4. CASE 25.034, 96 CHAPIN AVENUE, Cyrus T. Eddy House, 1875 (ARMORY)

Proposal: The scope of work proposed consists of Major Alterations and includes:

Recommendations: The staff recommends the PHDC make the following findings of fact:

PROPOSED WINDOW SASH REPLACEMENT
CYRUS EDDY HOUSE
96 CHAPIN AVENUE
PROVIDENCE, RHODE ISLAND 02909

ELEVATION COMPARISON

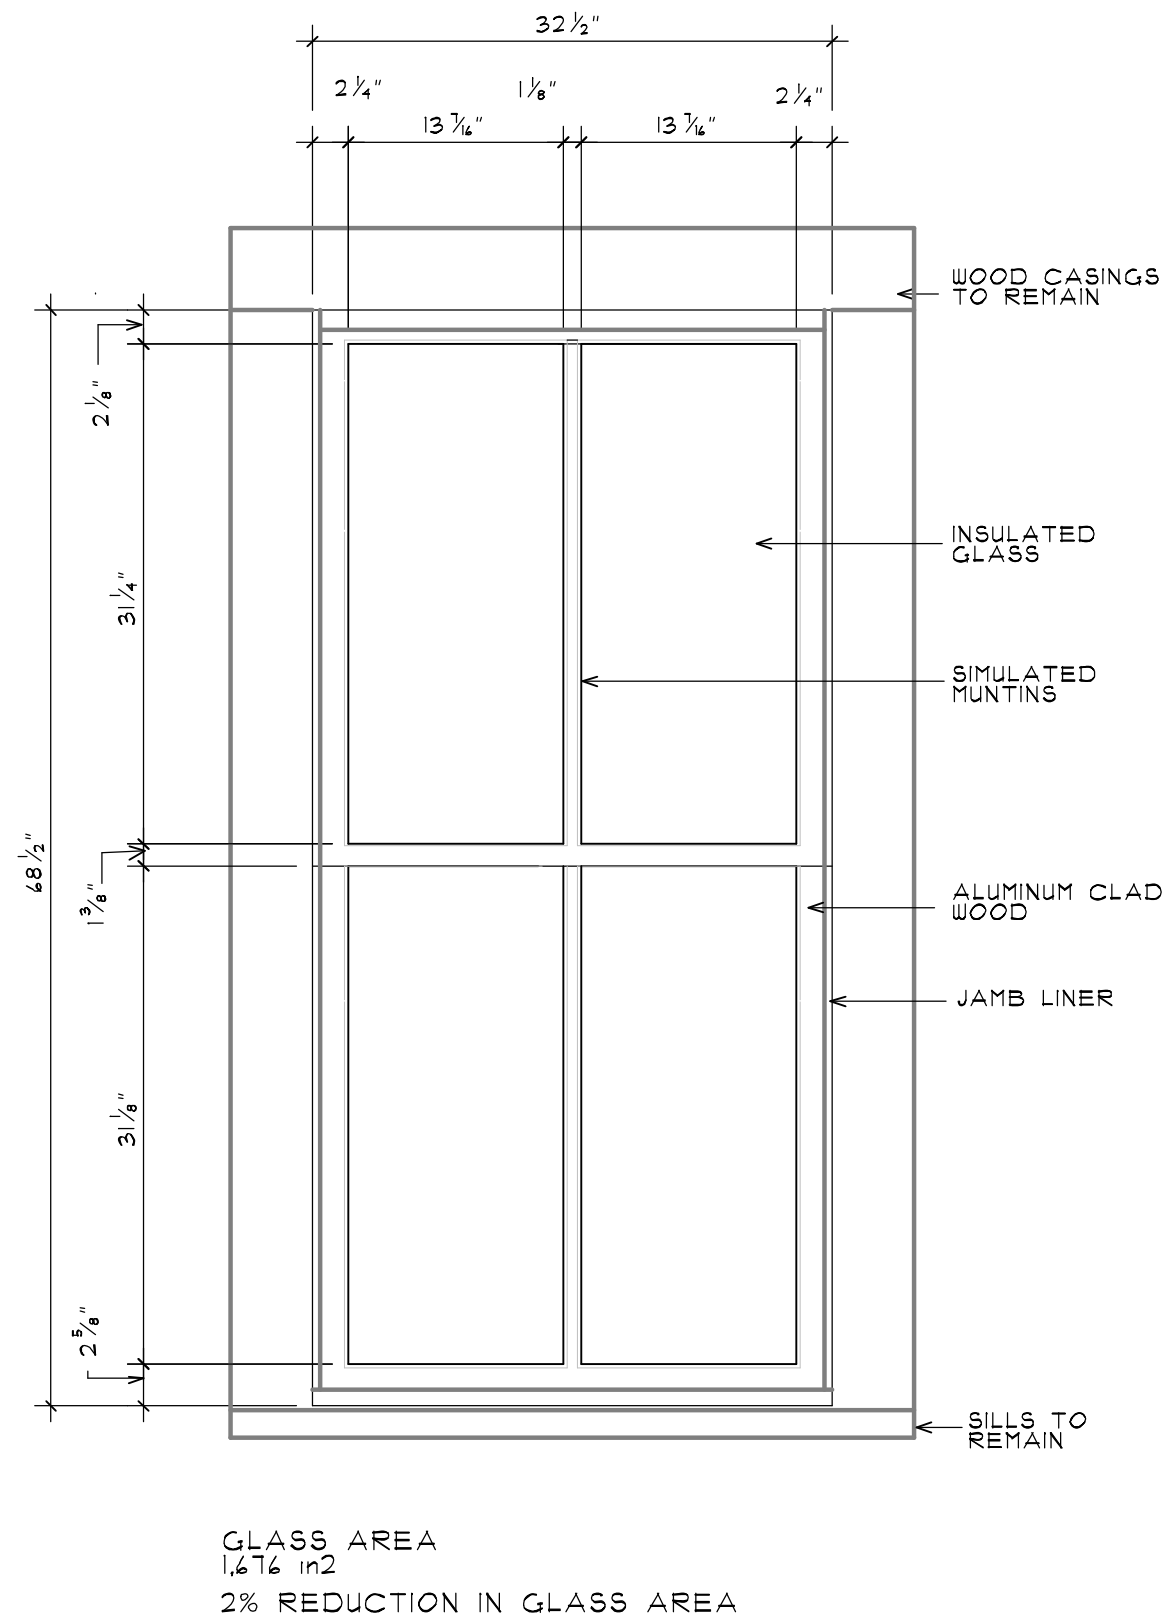
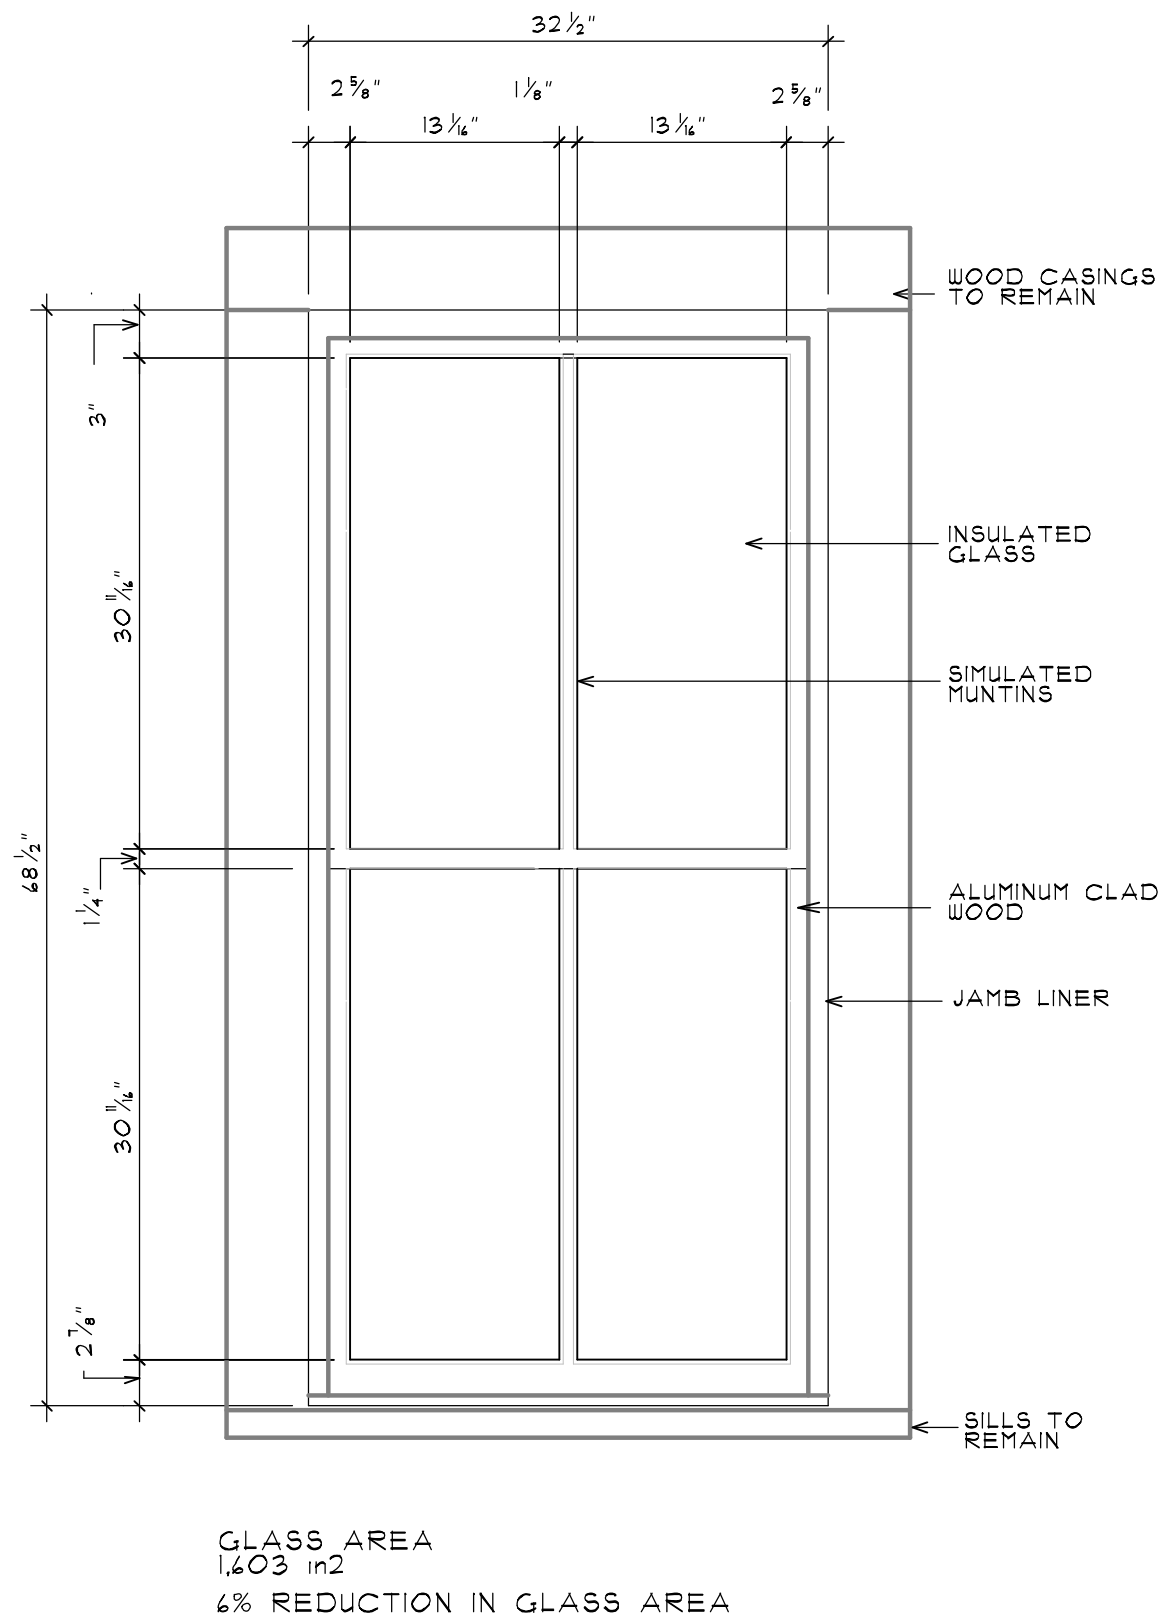
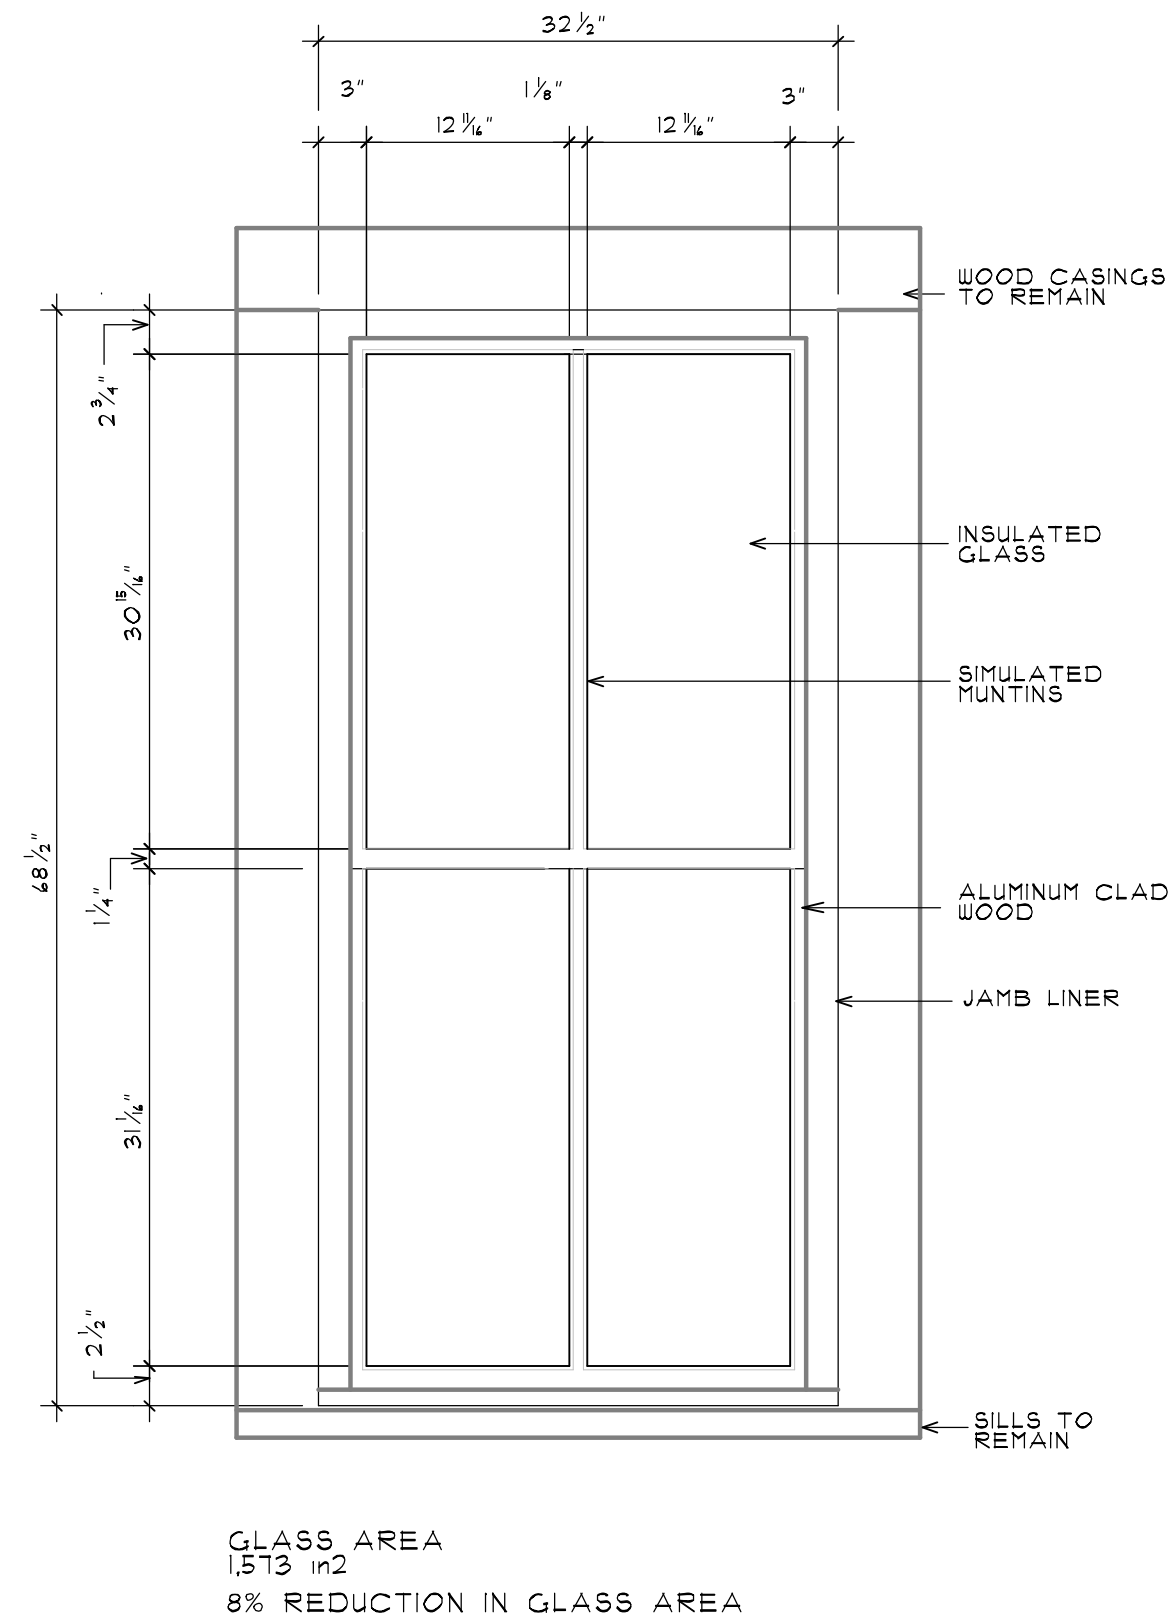
- The proposed replacement windows for this building will closely follow the design intent and function of the existing units. The window frames along with interior and exterior casings and trim are to remain. Improving building performance and safety, while maintaining design integrity is the goal of this work;

- b) The application for Major Alterations is considered complete; and,
- c) The work as proposed is in accord with PHDC Standards 2 & 8 as follows: the proposed alterations are appropriate having determined that the proposed construction will be similar in size and appearance to the existing, matching in visual features (Standard 2) and is architecturally and historically compatible with the property and district having an appropriate size, scale and form that while diminishing the historic quality of the property will not have an adverse effect on the property or district (Standard 8) while allowing the property to come into compliance with RIGL § 42-128.1-8.
